**AMENDMENT TO THE DRAWINGS**

**REMARKS/ARGUMENTS**

Application No: 10/796,968  
Attorney's Docket No: ALC 3119

FIGURE 7

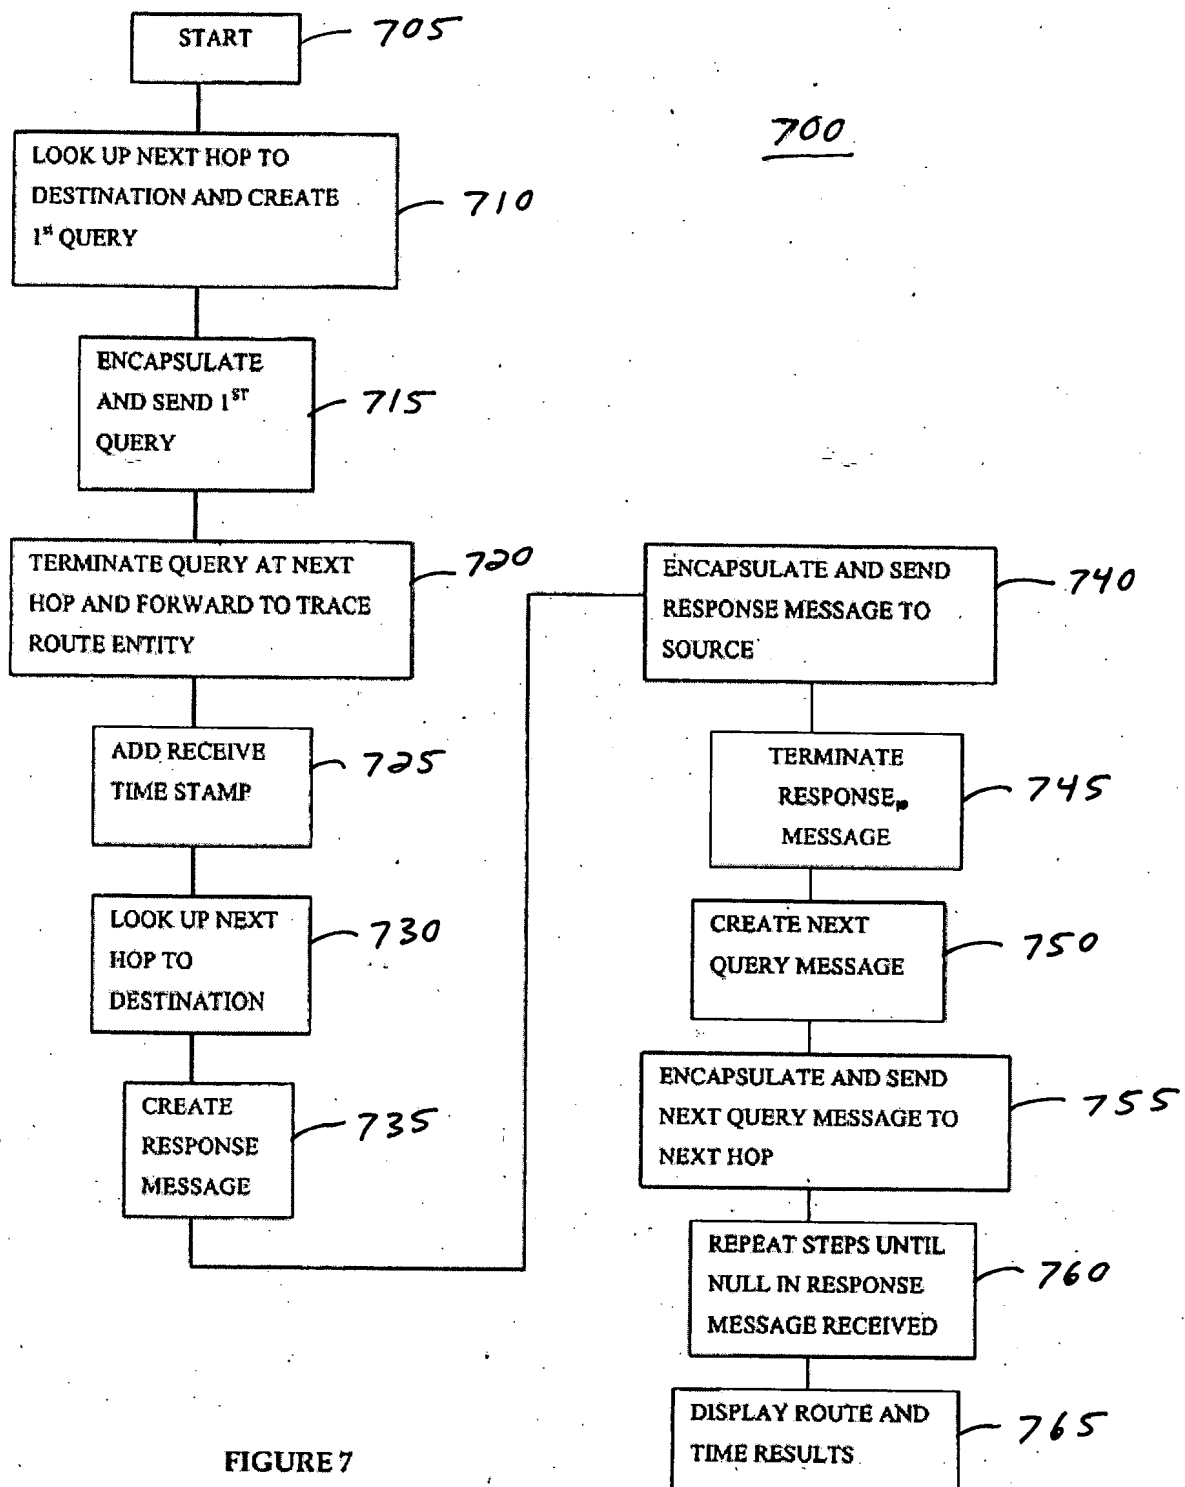
In sections 3 and 4 on page 3, the Office Action objects to Figure 7 for the specified reason. Figure 7 is corrected as requested by the Office Action. Applicant submits herewith a replacement sheet adding reference characters to all steps in Figure 7. In addition, as required by the Examiner, Applicant submits herewith an annotated drawing figure indicating the changes made to Figure 7. See 37 C.F.R. § 1.121(d)(2).

Applicant also notes that, with reference to Figure 7, paragraph [0063] is amended to make reference to the reference characters added to Figure 7, as required. For at least the foregoing reasons, Applicant respectfully requests that the objection to the drawings be withdrawn.

The attached replacement sheet makes changes to Fig. 7 and replaces the original sheet with Fig. 7.
